Committee: Cabinet Member report

Date: 18th October 2019

Subject: Proposed Balfour /Merton Rd junction– Statutory Consultation

Drawing No.	Z38-262 -01
Revision	-
Classification	DRAFT
Scale	N.T.S

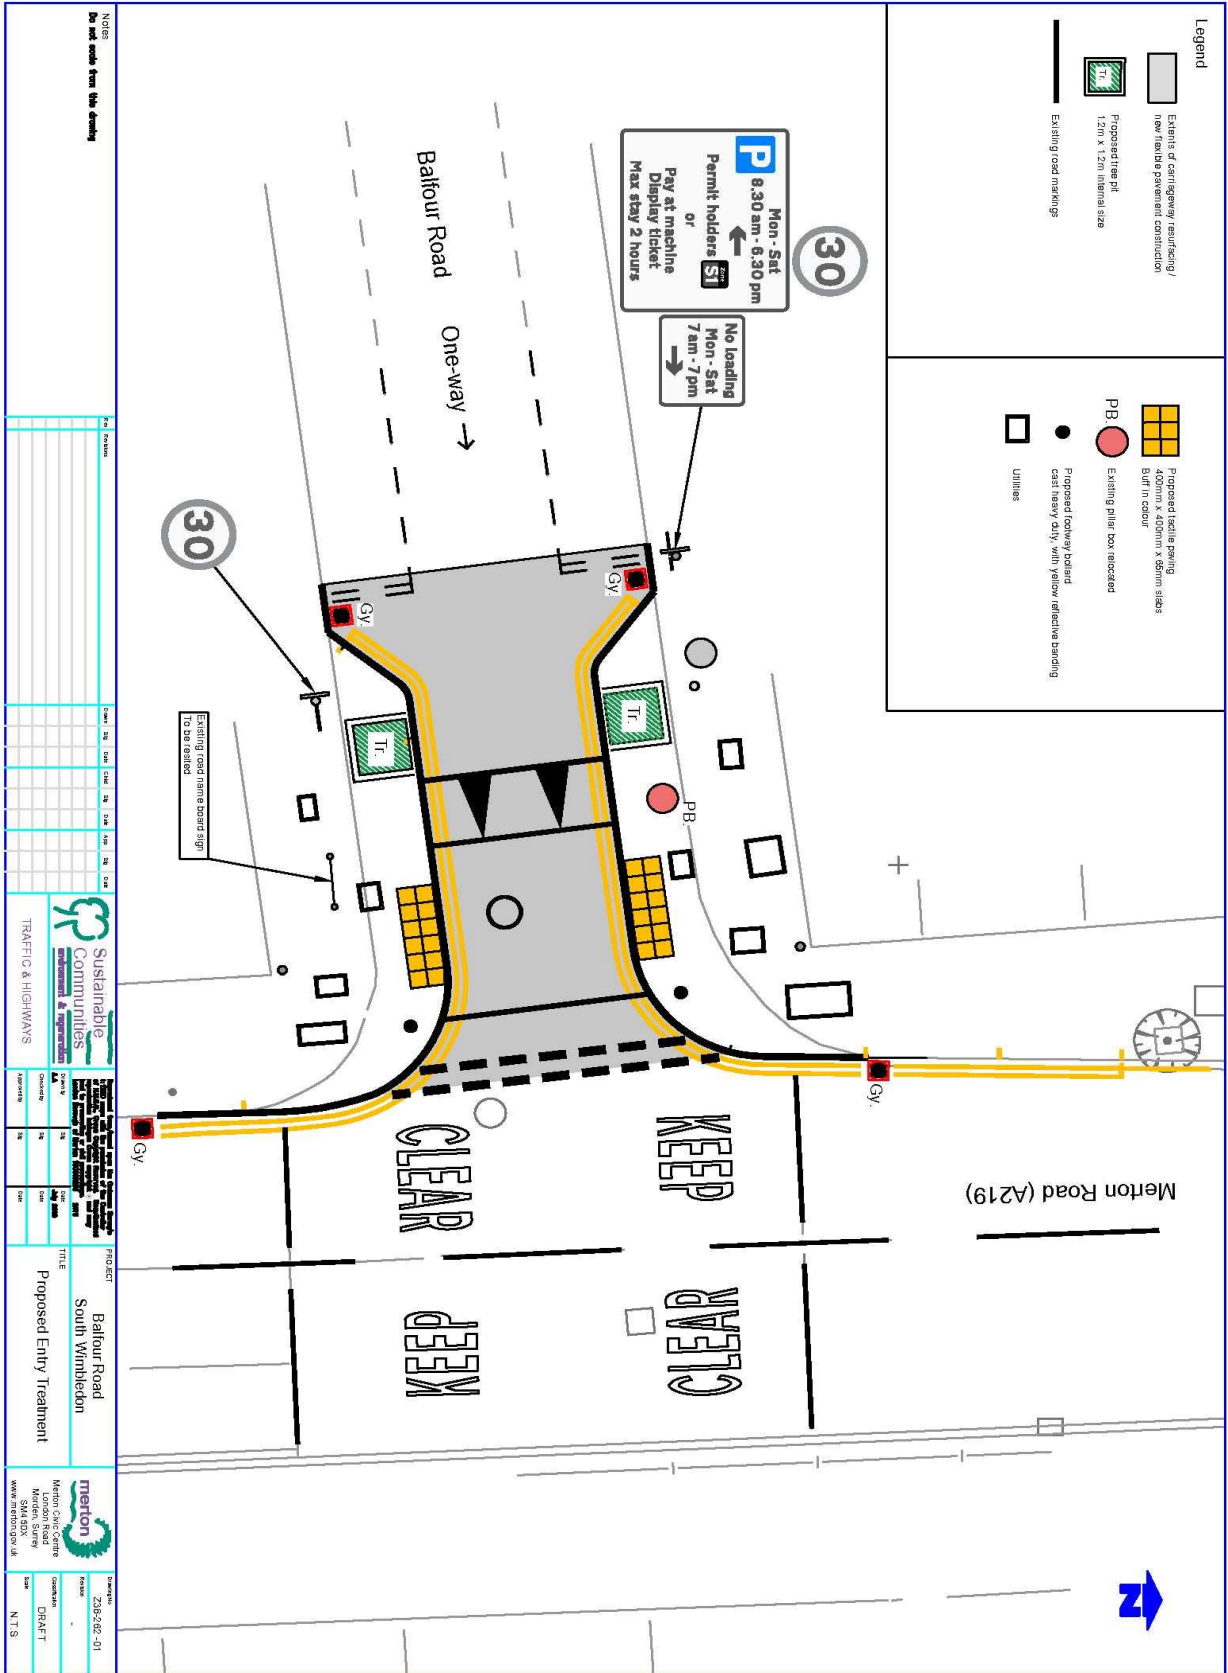
The supplied drawing Z38-262-01 fails to show the driveways on either side of Balfour Road that access the 'service areas' behind the properties in Merton Road. Please confirm that the proposals will not impact either their access or existing parking.

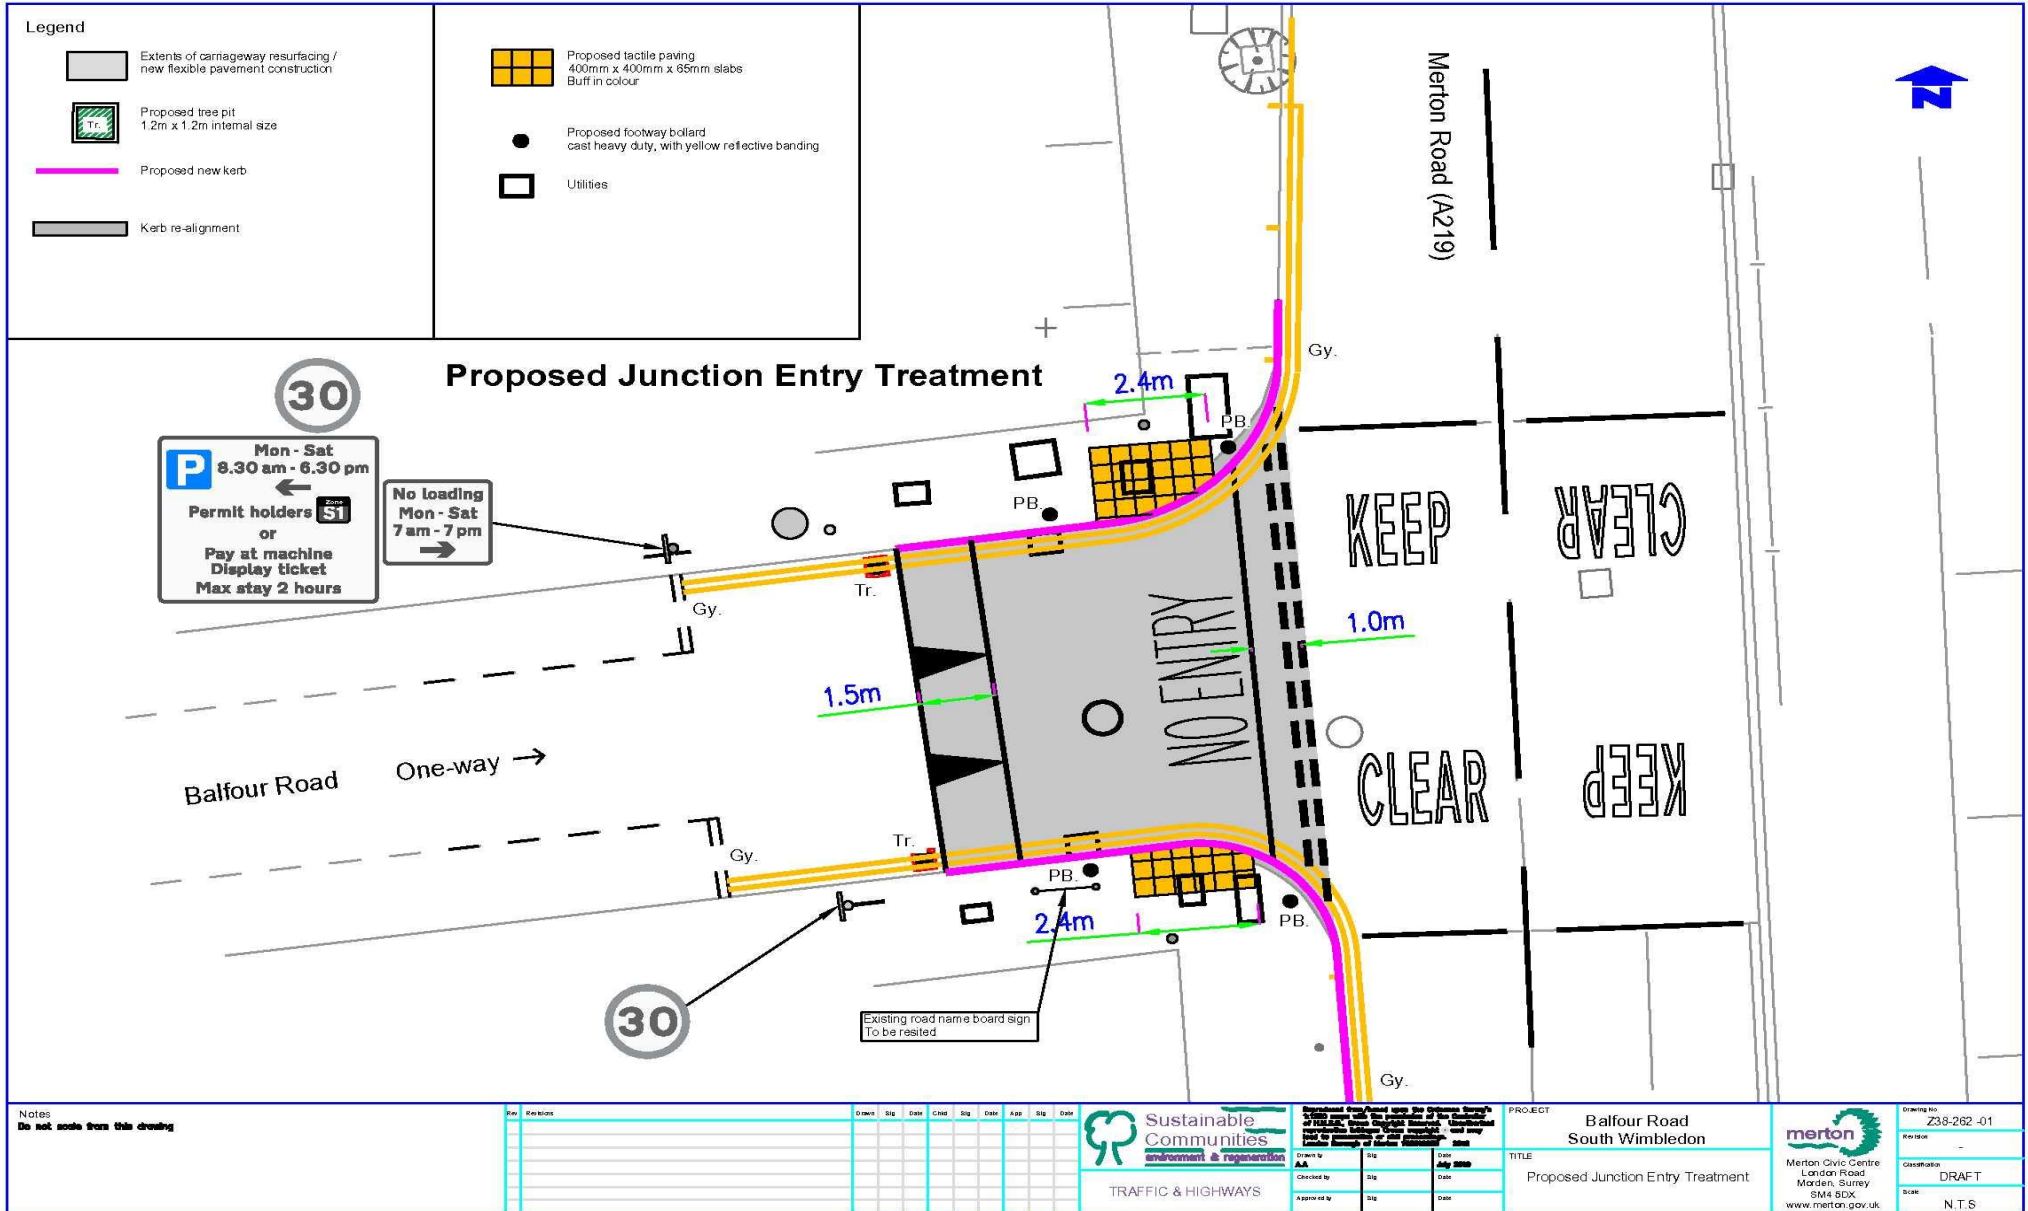
I am still not convinced by your newsletter and the response below that no parking spaces will be lost. The drawings aren't very clear. I would have preferred to see 'before' and 'after' plans. It seems impossible that no parking will be lost to this proposal. You may disagree with me (or I might be wrong) but as suggested in my previous email, I'm more than happy to show you around the area. I feel it would be better to be here so you can realise and see what would be the best solution.

In the attached photo, wouldn't it possible to remove the 'extended pavement area' (where the lamp/sign-post used to be) be removed to create two extra parking spaces for the residents? Or, may I ask why this 'extended' pavement is left there?
